SERVICE BULLETIN SB00.18

Machines/Models: LX31/41/50 2WD **Serial Numbers:** 1410 -2746

PURPOSE: Enhance Brake Durability

PROCEDURE REQUIRED: Install Orifice Fitting and adjust the Counterbalance Valves

Figure 1

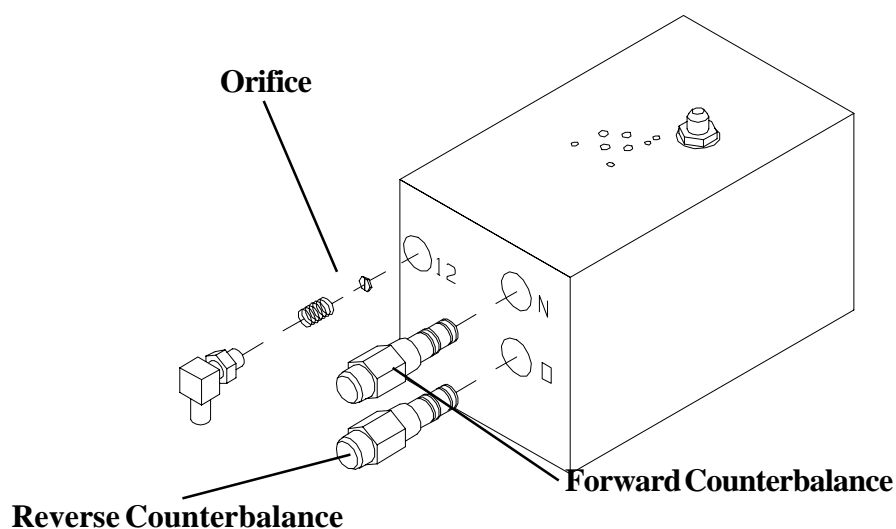
1. Locate the Forward (Reverse) Counter Balance Valve (see Figure 1).
2. Loosen the locknut.
3. Turn the valve clockwise until it gently rests against the seat.
4. Turn the valve counter clockwise 3 turns.
5. Torque the locknut to 3 Ft. Lbs (4 Nm).
6. Repeat steps 1 through 5 for the Reverse Counter Balance Valves as follows.
